# UNITED STATES PATENT AND TRADEMARK OFFICE

APPLICATION NO.	FILING DATE	FIRST NAMED INVENTOR	ATTORNEY DOCKET NO.	CONFIRMATION NO.
10/673,536	09/29/2003	Matthew G. Goulet	29641/39623	1848
4743	7590	11/08/2004		
MARSHALL, GERSTEIN & BORUN LLP 6300 SEARS TOWER 233 S. WACKER DRIVE CHICAGO, IL 60606			EXAMINER NGUYEN, GEORGE BINH MINH	
			ART UNIT 3723	PAPER NUMBER

## Office Action Summary

### **DETAILED ACTION**

FIG. 1

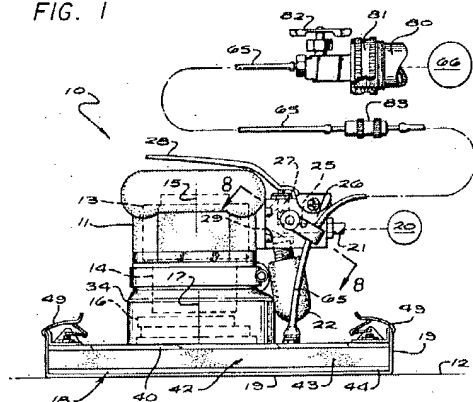
With reference to Figure 1, col. 3, lines 1-22, Hutchins discloses the claimed invention.

Please note that spring clip 49 has a cam surface at the end of pivot arm. The end cam surface applies a compressive force against the base 42 to hold the sand paper 19 onto the base.
